CITY OF BOULDER
PLANNING BOARD AGENDA ITEM
MEETING DATE: May 12, 2016

AGENDA TITLE: Public hearing and consideration of a Non-Conforming Use Review application, case no. LUR2016-00014 and simple Site Review, case no. LUR2016-00025 for expansion of the Quality Inn Boulder Creek/Basecamp Motel and 33 percent parking reduction with 43 existing parking spaces where 60 are required. The site is located at 2020 Arapahoe Ave. Because this is an existing non-residential use within a residential zoning district (Residential – High 1), the use is considered non-conforming. The applicant requests to expand the exterior patio from 159 square feet to 346 square feet, and convert existing floor area to increase the room count from 47 to 50 rooms that includes the addition of one fully compliant Americans with Disabilities Association (ADA) room. The applicant is requesting Vested Rights per Land Use Code section 9-2-7(b)(1), B.R.C. 1981.

Project Name: Quality Inn Boulder Creek/Basecamp Motel

Location: 2020 Arapahoe Avenue

1 LEVEL 1 FLOOR PLAN - PENDING REVIEW
3/32" = 1'-0"

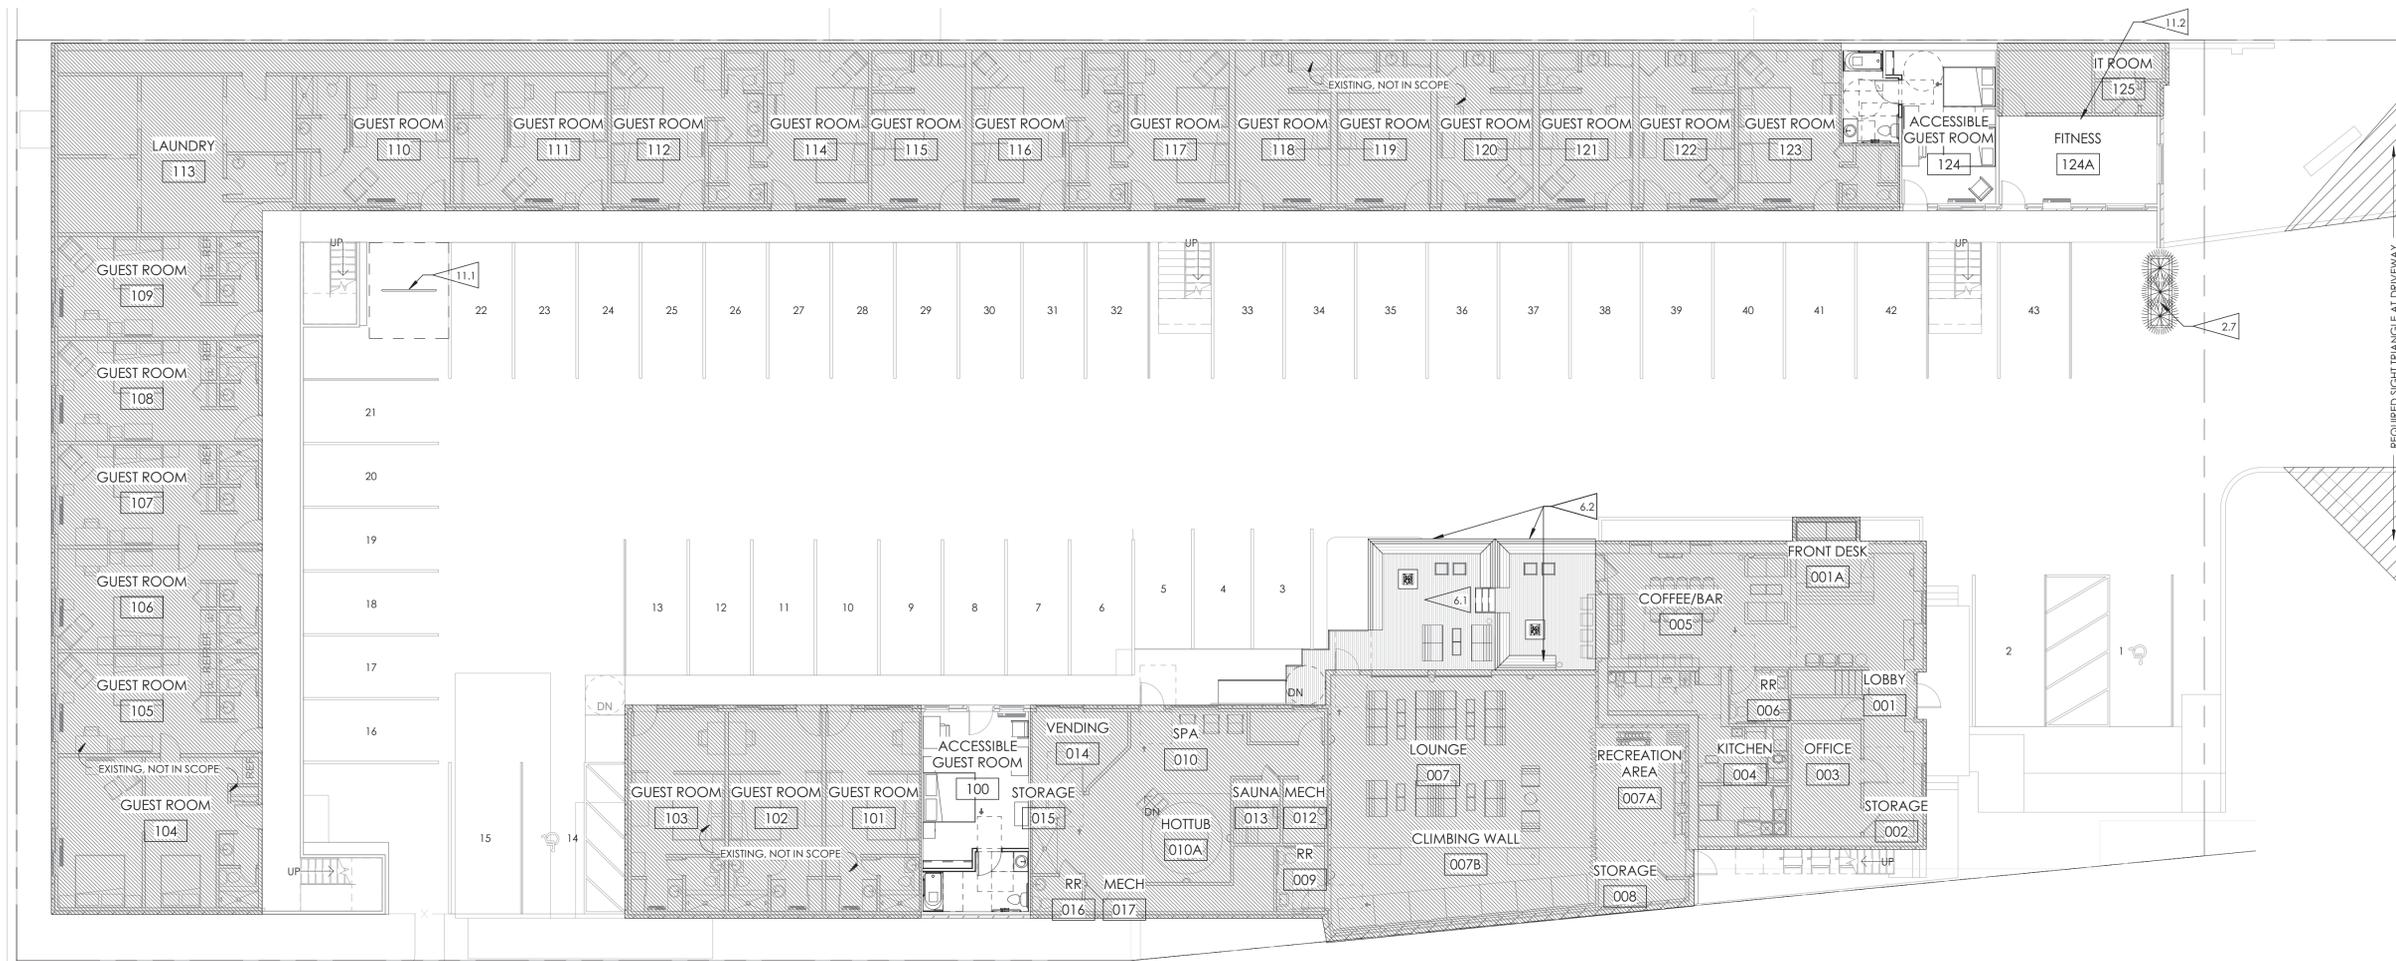
- b. Per Ms. Lokocz's request we have now shown our planter on the plans and have moved to screen the final parking space on the north side of the property.

Please update the plans and perspective to provide a single large planter adjacent to the stairs to help screen the parking lot. Smaller planters desiccate extremely quickly in the CO climate and will require significantly more watering. Call out the proposed vegetation. Note that the perspective should only be submitted if it matches the plans.

- FLAGNOTES PER SHEET**
- 2.7 NEW 3'-0" x 9'-0" PLANTER W/ SKYROCKET JUNIPER TO SCREEN PARKING FROM STREET.
 - 6.1 NEW EXTERIOR WOOD DECK: NET 346 SF.
 - 6.2 SITE FABRICATED WOOD BENCH/GUARDRAIL.
 - 11.1 BICYCLE RACK TO CONFORM TO WITH SECTION 9-9-6(g)(2) & (3) OF THE BRC 1981 AND TECHNICAL DRAWING 2.52.B OF CITY OF BOULDER DESIGN & CONSTRUCTION STANDARDS.
 - 11.2 VERTICAL 2 BIKE STORAGE SYSTEM.

Please see attached Landscape Plan in Exhibit C with vegetation and locations called out. We have landscaped every piece of land that is not used by circulation, traffic, buildings or trash. We believe that the new planters do a fine job of screening the parking lot given the limited areas we have for landscaping.
